PROPOSED CHANGE NOTICE

2445-01

RE: AURORA FOOD STORE
 2000 ANAQUOD ROAD
 REGINA, SK
 Commission No. 2445

RE: Storm Connection

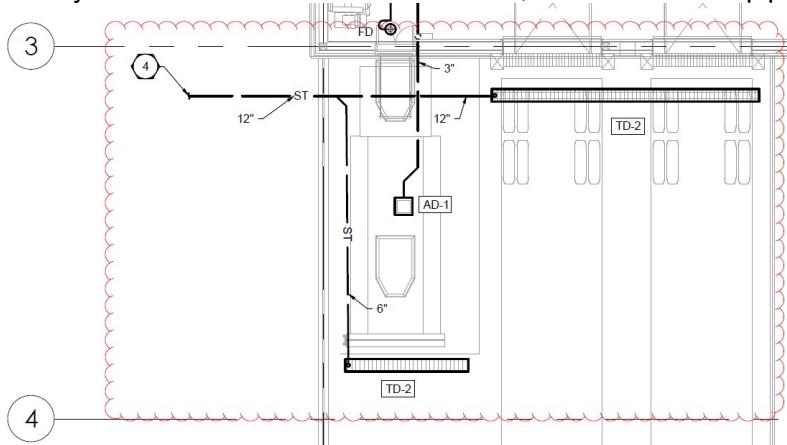
- .1 Refer to drawing M1.1 FOUNDATION PLAN PLUMBING AND PIT.
 Modify Keynote #4 to refer to 12" storm sewer size.
 Modify storm line connection size/location, and trench drain pipe size:

- .2 6" outlets on the trench drains are acceptable. Mechanical Contractor to upsize to 10" before they combine as per the tender drawings. Contractor to upsize again to a 12" near the service connection to reduce the amount of material costs for the project.
- .3 Quorex to coordinate storm line connection with Landlord's civil scope/location.
